# UNITED STATES PATENT AND TRADEMARK OFFICE

10/534,438

## Office Action Summary

## **DETAILED ACTION**

**Figure 9c,**

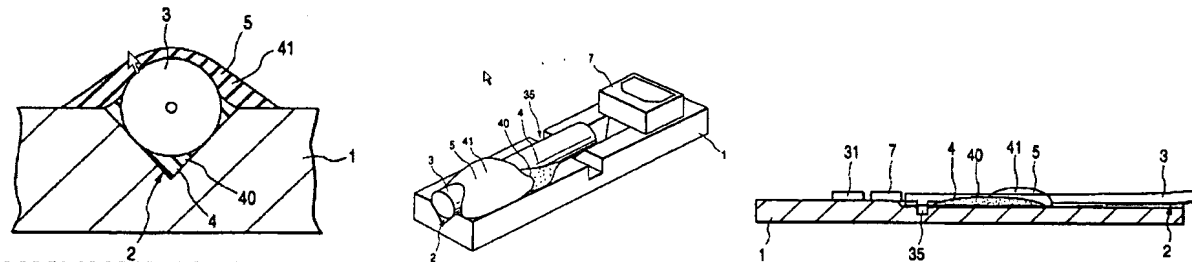
Regarding claims 1, Takahashi teaches a laser module (shown in at least fig. 14), comprising: a substrate 1; a semiconductor laser 7 secured to a surface of the substrate 1; and an optical waveguide device 3 joined to the surface of the substrate 1 by an adhesive layer 40 so that the optical waveguide device is coupled optically with the semiconductor laser 7, wherein a first groove is formed at the surface of the substrate 1 at a region corresponding to an incident end side of the optical waveguide device 3, the first groove 35 being formed parallel to an outgoing end face of the

semiconductor laser 7 with a predetermined space therefrom, and the adhesive layer 40 is formed so that an end portion of the adhesive layer on the incident end side of the optical waveguide device is positioned inside of the first groove so as to adhere to a surface of a wall of the first groove under the optical waveguide device and does not contact with the outgoing end face of the semiconductor laser (see at least fig. 9b-c, 8 and 14-15; wherein the 2<sup>nd</sup> embodiment is similar to the 1<sup>st</sup> embodiment with regard to adhesive layer 40, shown in fig. 9c above, except to the portion 5 which is not relevant to the claimed invention, col. 17, 3<sup>rd</sup> parag.).

Regarding applicant's assertion that Takahashi does not teach the adhesive layer is positioned inside of the first groove so as to be in contact with a surface of a wall of the first groove and does not contact with the outgoing end face of the semiconductor laser. The Examiner responds that indeed Takahashi teaches the adhesive layer 40 is formed so that an end of the adhesive layer on the incident end side of the optical waveguide device is positioned inside of the first groove so as to be in contact with a surface of a wall of the first groove and does not contact with the outgoing end face of the semiconductor laser (see at least fig. 9b-c and 14-15; wherein

the 2<sup>nd</sup> embodiment is similar to the 1<sup>st</sup> embodiment with regard to adhesive layer 40, shown in fig. 9b-c, except to the portion 5 which is not relevant to the claimed invention; see col. 17, 3<sup>rd</sup> parag.).
